STAFF ANALYSIS

CASE NO.:	Z-25-1247529	**File ID #:** 2025-0628
Address:	3265 Northeast Expressway, Chamblee, GA 30341	**Commission District: 01** **Super District:** 07
Parcel ID(s):	18-267-01-003	
Request:	Rezone property from C-2 (General Commercial) zoning district to HR-1 (High Density Residential-1) zoning district to allow single-family, attached, and multi-family developments.	
Property Owner(s):	Reality Income Corporation	
Applicant/Agent:	LMPSF Acquisitions, LLC c/o Troutman Pepper Locke, LLP	
Acreage:	23 acres	
Existing Land Use:	Formally Regal Cinemas	
Surrounding Properties:	**North:** OI (Office Institutional) **East:** OI **South:** MR-2 (Medium Density Residential - 1), R-100 (Residential Medium Lot-100) **West:** C-2 (General Commercial).	
Comprehensive Plan:	RC (Regional Center) __X__ **Consistent** ____ **Inconsistent**

STAFF RECOMMENDATION: Full Cycle Deferral_revised 07.09.2025

SITE PLAN

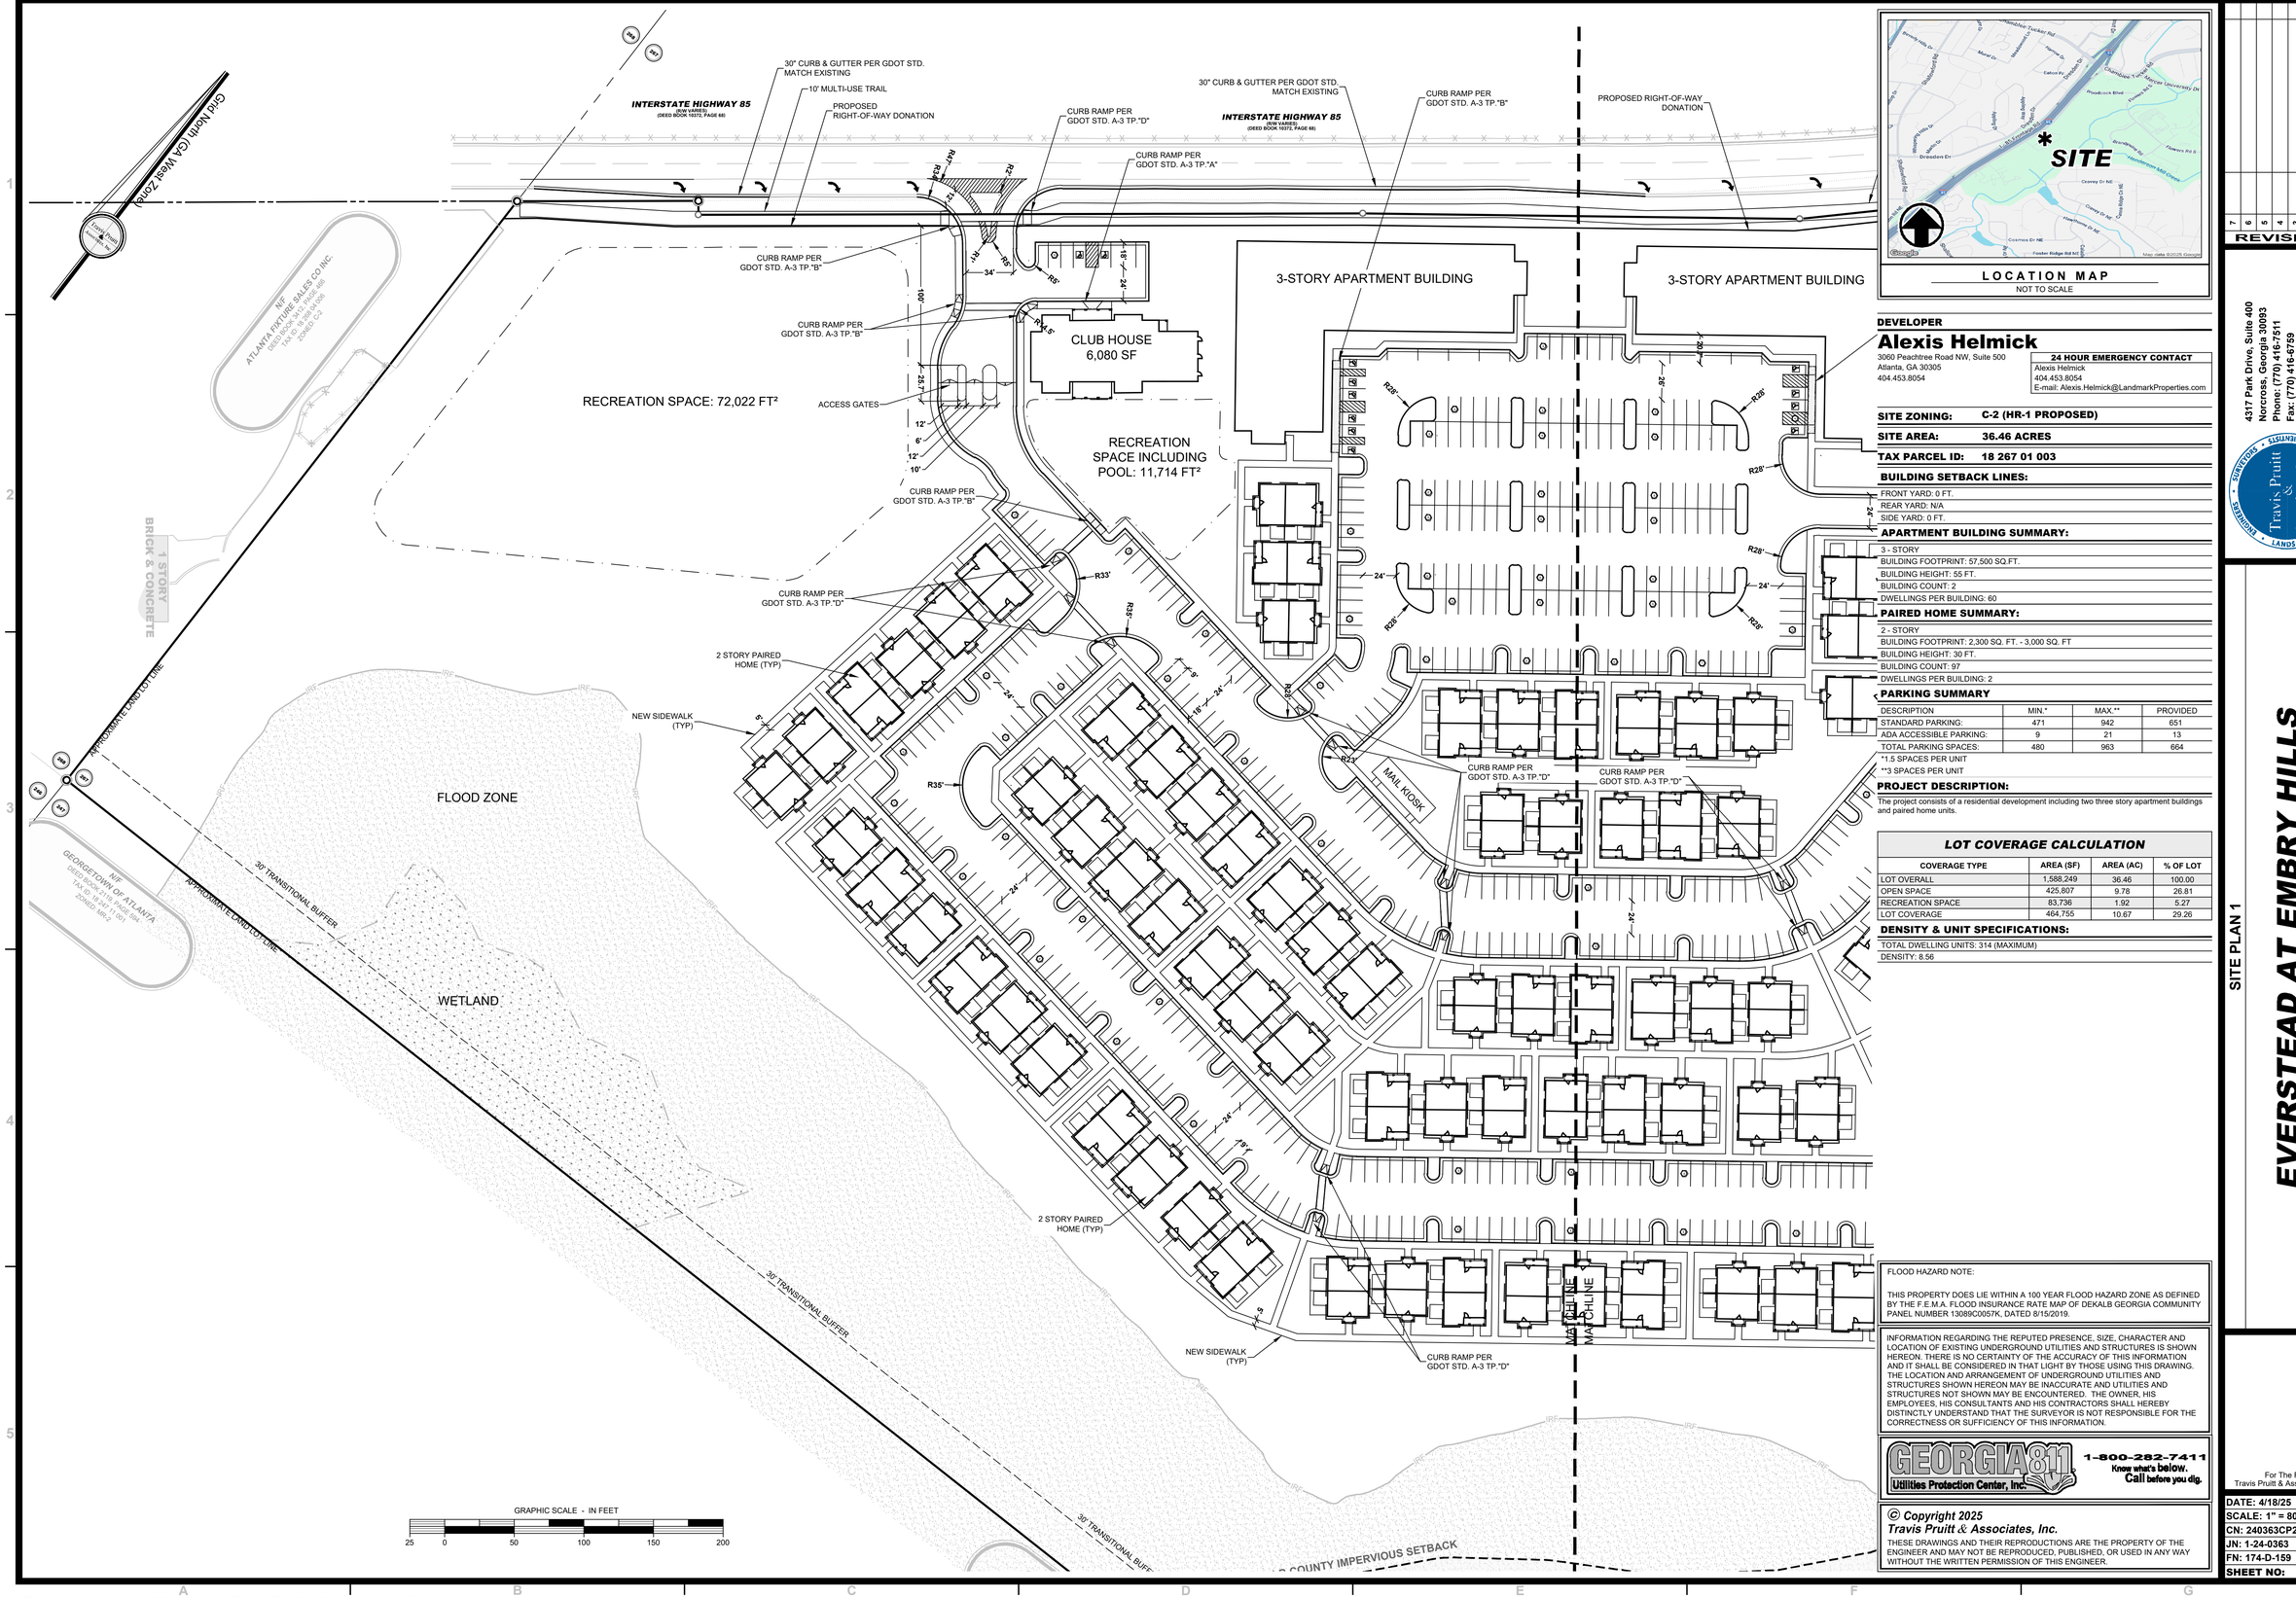
2. The site plan is conceptual; however, the road connectivity and pedestrian walkways shall be maintained or improved. Alterations to the site plan (Everstead at Embry Hills, dated 4/18/25) to better support other compact pedestrian-oriented improvements such as but not limited to, a connection to the "Recreation Park" or enhanced open space around the stormwater detention facilities, are subject to approval of the Planning Director.
